# PRODUCT SERVICE NOTICE

PRODUCT/APPL. WANG MATRIX MODEL 77

PCB #210-7131, ECN's #11307 and #11497, E REV 2  
for 2261V and 2261W Matrix Printers

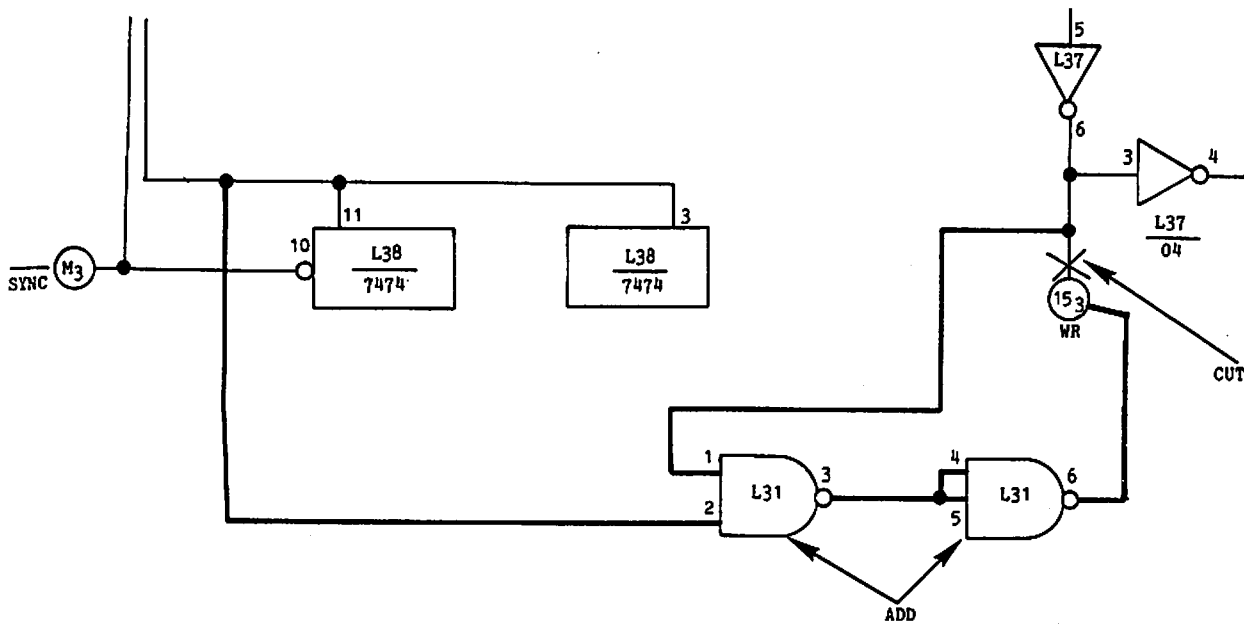
To enable the use of Texas Instrument PROMs in Character Font locations L1, L4, L6 and L8.

Add gating to delay WR signal.

1. Cut the etch at the base of L37 pin 6.
2. Add a wire from L37 pin 6 to L31 pin 1.
3. Add a wire from L38 pin 3 to L31 pin 2.
4. Add a wire from L31 pin 3 to L31 pin 4.
5. Add a wire from L31 pin 4 to L31 pin 5.
6. Add a wire from L31 pin 6 to pin 15 of connector 3.
7. Increment the E-REV to 2.
8. Update the 7131 schematics to reflect this change. Refer to Figure 1.

7232/7232-1 COMPONENT LAYOUT

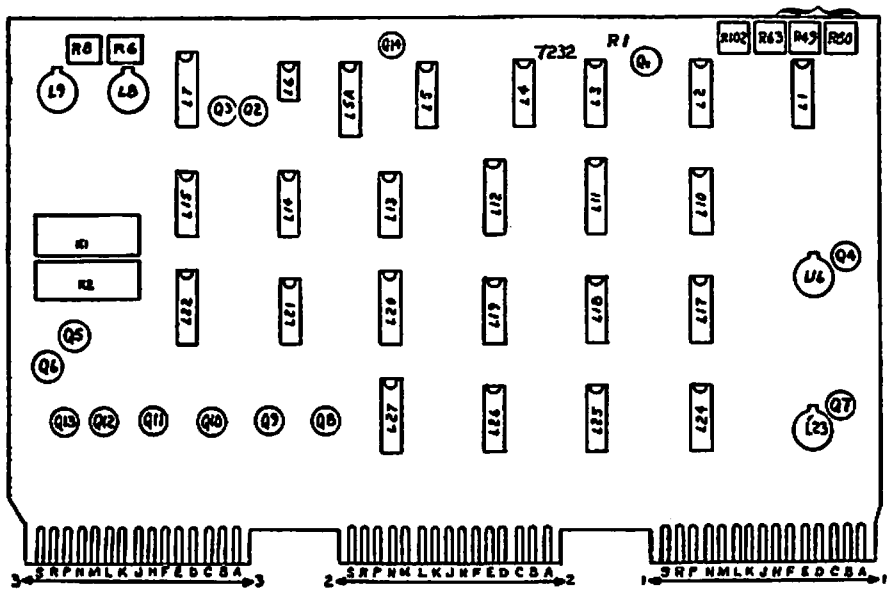
Intensity adjustments to the LEDs in the photocoupler amplifiers on 7232/7232-1 boards are too sensitive with the 100-Kohm potentiometers (pots) presently used. Original specifications call for the use of 100-ohm pots in the LED-intensity adjustment circuits.

Replace the 100-Kohm pots at R49 and R80 with 100-ohm pots.

Replace 100K Ohm POTs  
At These Locations (R49, R80)  
With 100 Ohm POTs

1. Replace 100-Kohm pots at locations R49 and R80 with 100-ohm pots. (See Figure.)
2. Perform adjustments described in Section 5.2.2, Paragraph 2 (Window Signal Duty Cycle), of the Model 77 Quad Head Maintenance Manual (03-0061, III.C.2). This procedure was written for the 210-7132 board; however, except for changes in component callouts, it applies to the 7232/7232-1 boards as well. In the maintenance manual, R46 is the 12-pitch LED adjustment pot and R24 is the 10-pitch LED adjustment pot. In the 7232/7232-1 schematics, these pots are labeled R80 and R49 respectively.
3. Increment the E-Rev. sticker on the 7232 board to level 4. Increment the E-Rev. sticker on the 7232-1 board to level 1.

FIGURE 1 210-7232 PCB, COMPONENT SIDE

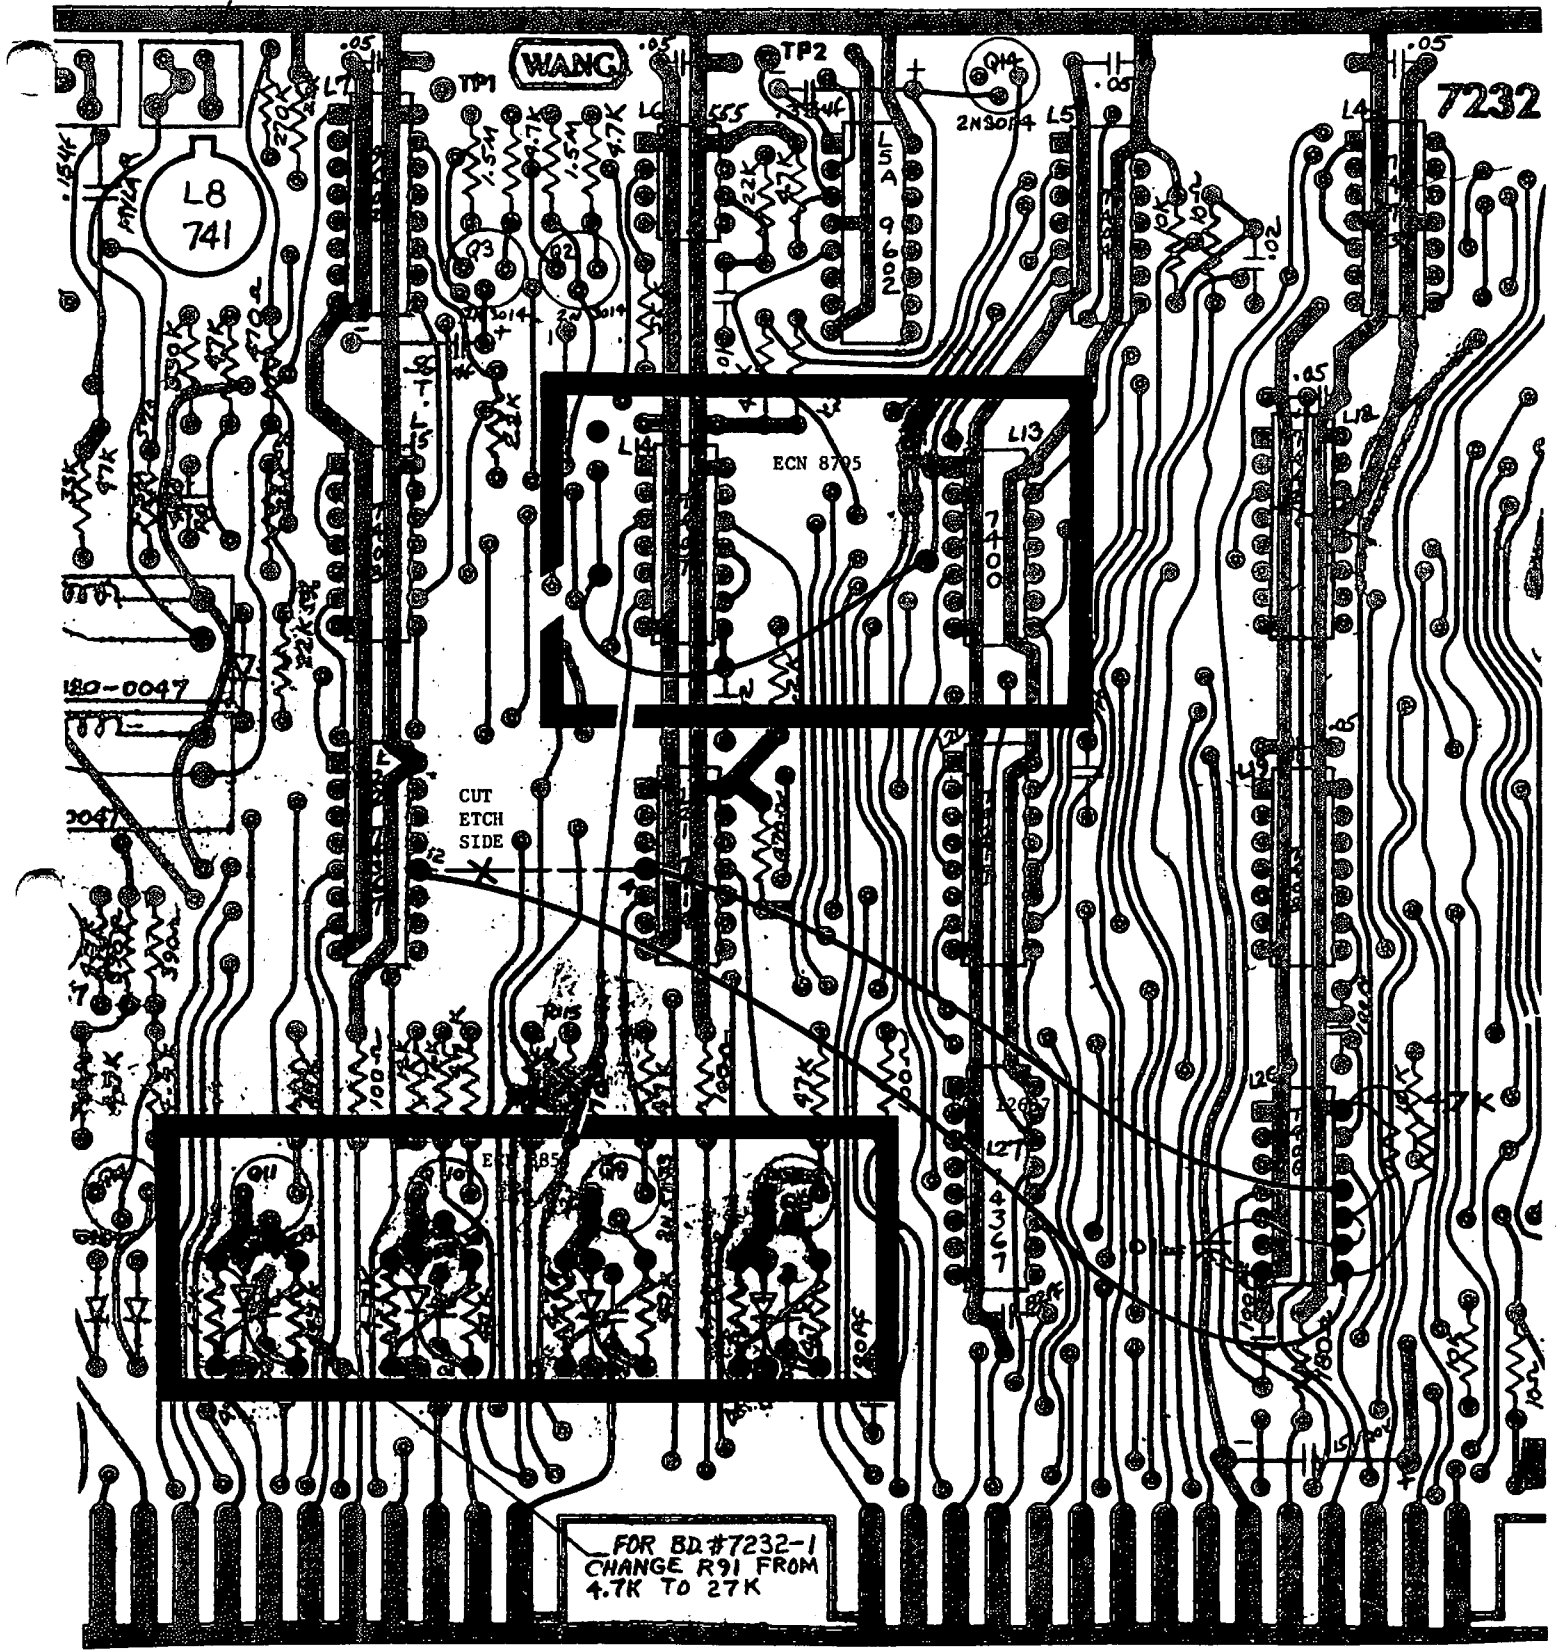
To eliminate top and bottom of form problems.

Add circuitry to stabilize the Photosensor outputs.

To eliminate intermittent top-of-form problems

Install noise-suppression circuitry

1. Remove the 22K resistor located below Q8 and replace it with a 4.7K resistor (WL #330-3047).
2. Remove the 47K resistor located below Q8 and replace it with a 4.7K resistor.
3. Connect a diode (WL #380-1001-4B), between pin S<sub>2</sub> an Q8's emitter, with the anode connected to Q8, as shown in the figure.
4. Repeat steps 1, 2 and 3 for the identical circuits associated with Q9, Q10 and Q11.

1. On the non-component side of board, cut the etch between L21 pin 4 and L22 pin 12.
2. On the component side of board, perform the following:
  - a. Jumper L21 pin 4 to L26 pin 11.
  - b. Jumper L26 pin 9 to L26 pin 10.
  - c. Jumper L26 pin 8 to L22 pin 12.
  - d. Add a 4.7-kohm resistor between pin 10 and pin 14 of L26.
  - e. Add a 4.7-kohm resistor between pin 8 and pin 14 of L26.
  - f. Add a .01-uF capacitor between pin 7 and pin 9 of L26.
3. Increment the E REV sticker to 3.
4. Update the schematic to reflect this change. Refer to Schematic.

FIGURE 1 ECN's #7181, #7712 and #9424

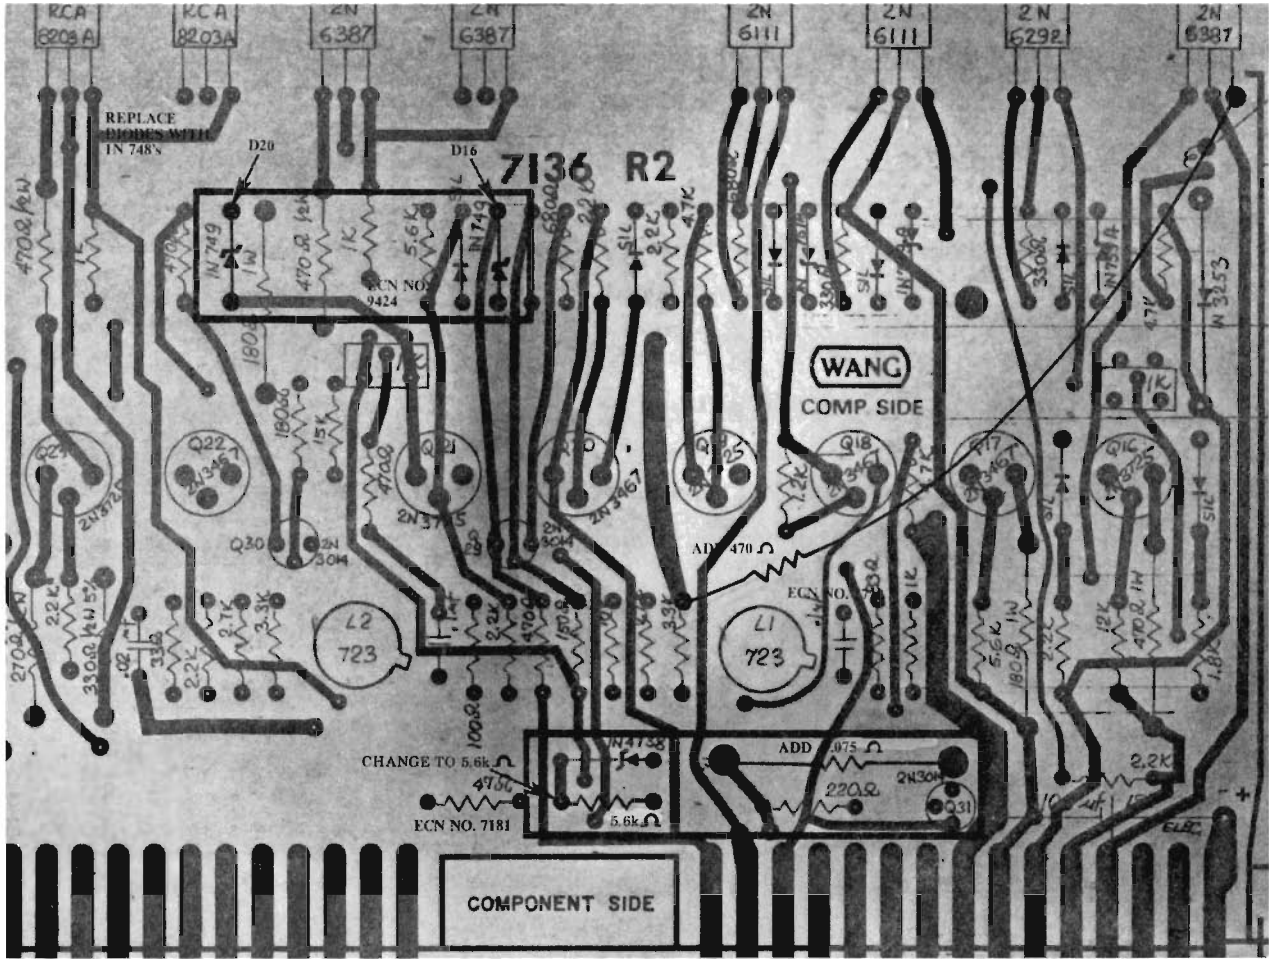
Design improvement for better regulation.

To eliminate solenoid misfiring when the printer power is turned off.

The +12 VR and the -12 VR switching control is too critical.

1. Replace R66 (3.3K ohm) with the 5.6K ohm resistor.
2. Add the .075 ohm resistor between 13<sub>1</sub> (+5VR) and the emitter of Q31 (2N3014). This resistance was previously attained by installing two 0.15 ohm resistors in parallel.
3. Increment the E REV from 0 to 1.

1. Insert the 470 ohm resistor between L1 pin 5 and the +12 volt run at the emitter of Q1.
2. Increment the E REV from 1 to 2.

1. Remove D20, located above Q22, and, observing the same polarity, replace it with a 1N748 diode.
2. Remove D16, located directly above Q29, and, observing the same polarity, replace it with a 1N748 diode.
3. Increment the E REV from 2 to 3.

FIGURE 2 ECN #10883

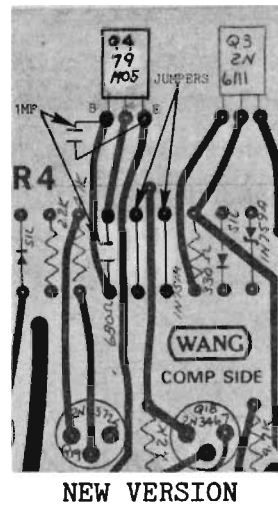
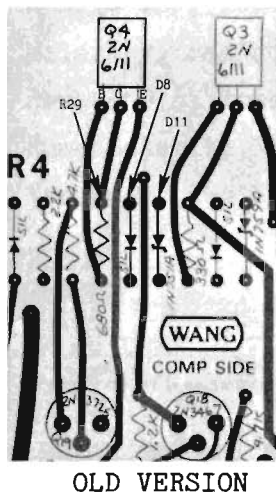
To improve the -5V regulator circuit. The existing component tolerances cause high failure rates.

To change the tolerances of the transistor regulator and the associated -5V regulator circuit components.

FIGURE 3 UPDATED SCHEMATIC, 210-7236 PCB

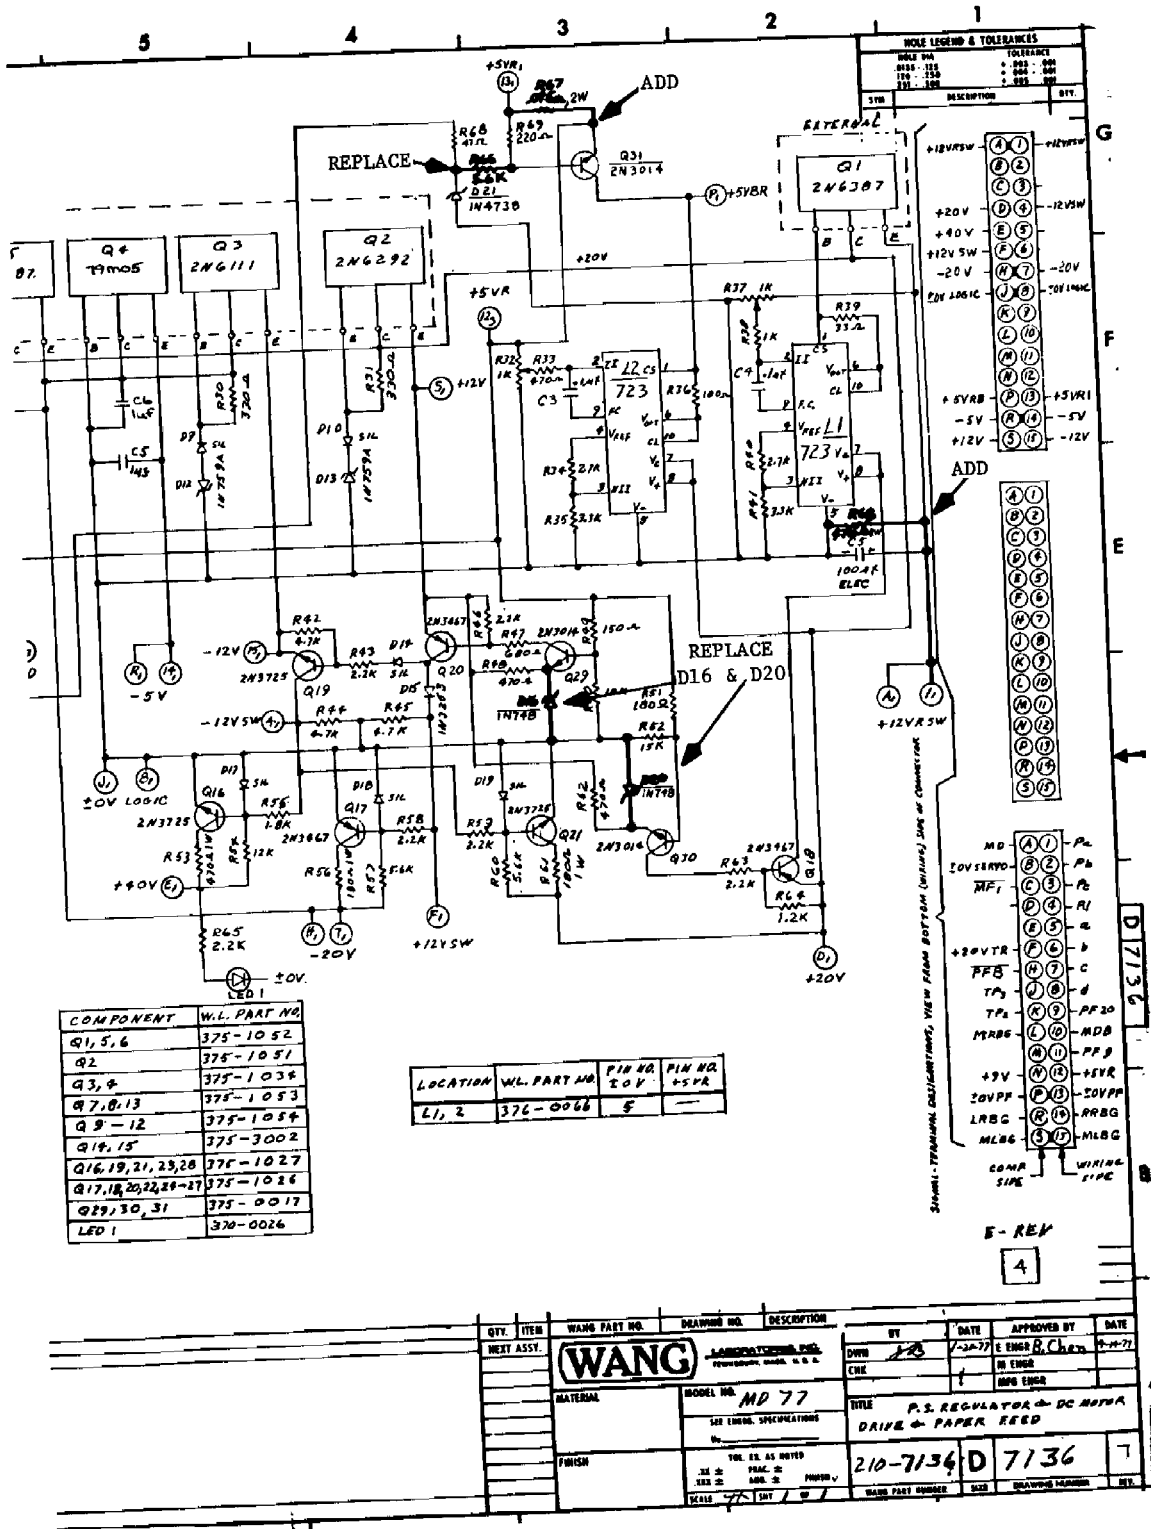
The ECN's presented in this PSN apply to the 210-7136 PCB for operation in the 2261W and the 2261V model printers. The prerequisite for installation of each ECN is that all previous ECN's are incorporated. For clarity and ease of installation, each ECN is documented independently. Refer to the figures, which depict actual component locations and wiring changes as well as updated schematic representations. Figures 1 and 2 show the physical locations of the component changes, and Figure 3 is the schematic update after all four of the ECN's have been incorporated.

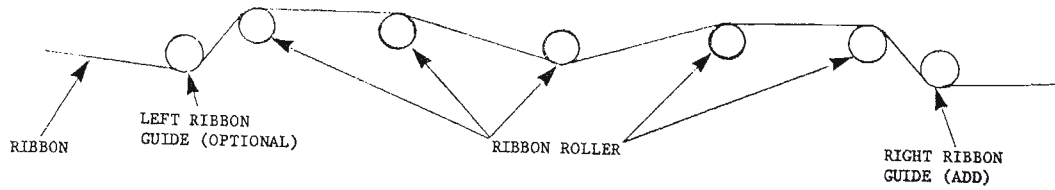
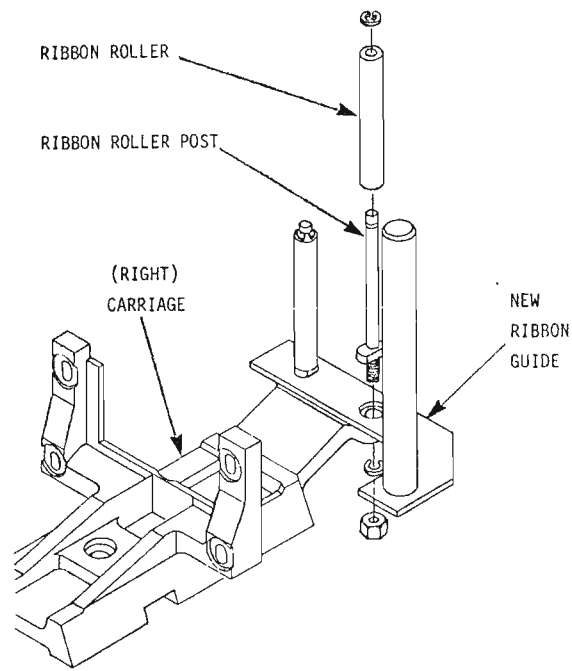
A new ribbon has been designed that supercedes the ribbon guide described in ISN #100. The new ribbon guide is designed to prevent paper streaking and to prevent the ribbon from jumping out of position. This new ribbon guide is available in limited quantity, in the Area offices. If additional ribbon guides are required they may be ordered from William Dorazio, Home Office by submitting request for a *MODEL 2261 RIBBON GUIDE* and the name of the customer where the ribbon guide(s) will be installed.

1. Remove old ribbon guide (if installed).
2. Remove two ribbon rollers.
3. Remove two ribbon roller posts.
4. Align new ribbon guide over roller post holes.
5. Reassemble in reverse order (step 4 to step 2).

FIGURE 1

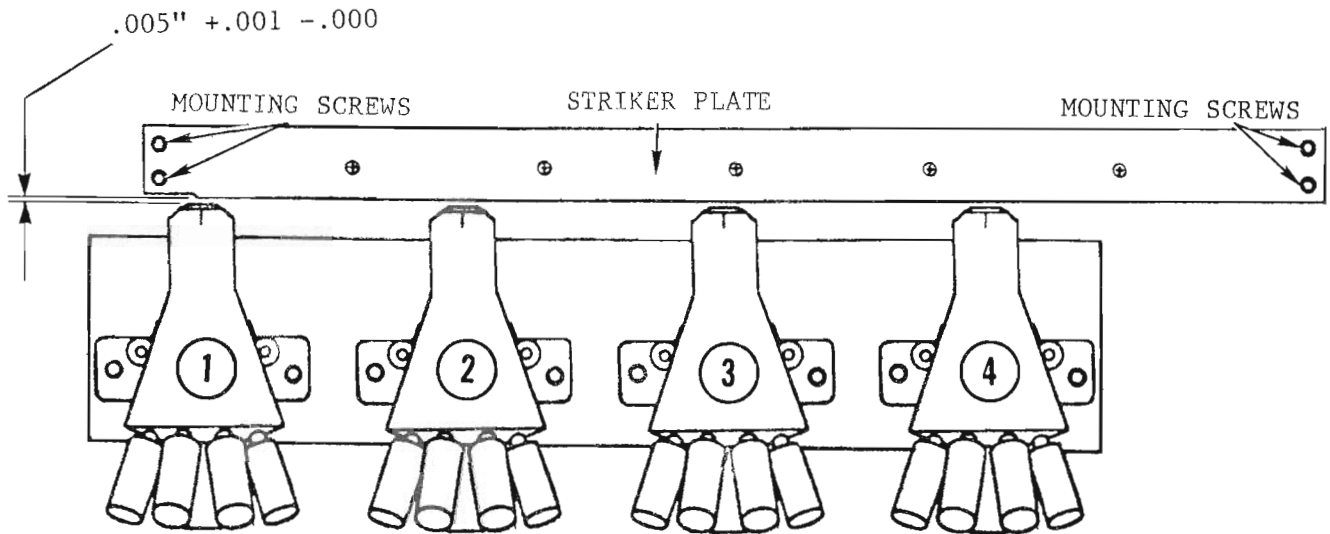
Some Model 77 (2261W) Matrix Printers have experienced solenoid wire breakage problems. The most common cause of these print head failures is incorrect striker plate alignment. If the print head bearing to striker plate clearance is less than .005" when the head adjustment arm is set to maximum penetration (due to incorrect alignment), the solenoid wires may break during firing.

By the procedures that follow, check the clearance from the print head bearings to striker plate. If the clearance is less than .005" when the print heads are set to maximum penetration (with ribbon and paper removed), adjust the striker plate to obtain the correct gap of .005" + .001"-.000".

1. Loosen the two Allen head screws at each end of the striker plate.
2. Move the striker plate forward or back (the rear paper guide will also move) until it is parallel to the main carriage. Tighten the Allen head lock screws and perform the striker plate adjustment check.
3. Repeat steps 1 and 2 until the gap from the striker plate to the print head bearings changes less than .001" as each print head moves from margin to margin.

FIGURE 1 7132 PCB OPTICAL SIGNAL, PAPER FEED & MOTOR CONTROL

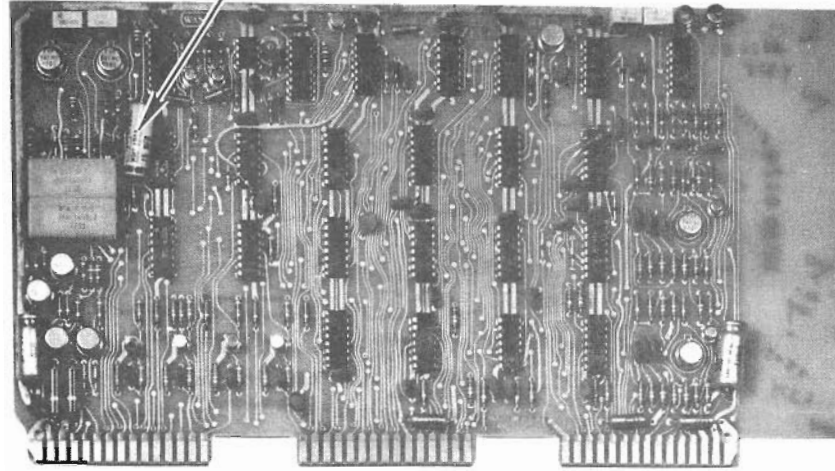
The tachometer circuit on this board has a mylar capacitor (C7) across the signals TACH+ and TACH-. When this capacitor has been punctured and shorted out by the sharp pins of adjacent boards, the two tachometer signals are then shorted together, leaving the tachometer inoperative. The carriage servo motor is left with no tachometer to govern its speed, and the carriage moves at more than twice its normal rate.

Capacitor C7 is the yellow, 100VDC, .15 Microfarad mylar capacitor near the side of the board (See Figure 1). If these symptoms occur, replace the capacitor (WLI #300-2215).

The capacitor is damaged when the board is shipped or handled improperly. To prevent this problem, do not stack any boards on the component side of the 7132 board. Always isolate the 7132 board by wrapping it in Styrofoam packing material or by keeping it separate in its own shipping envelope.
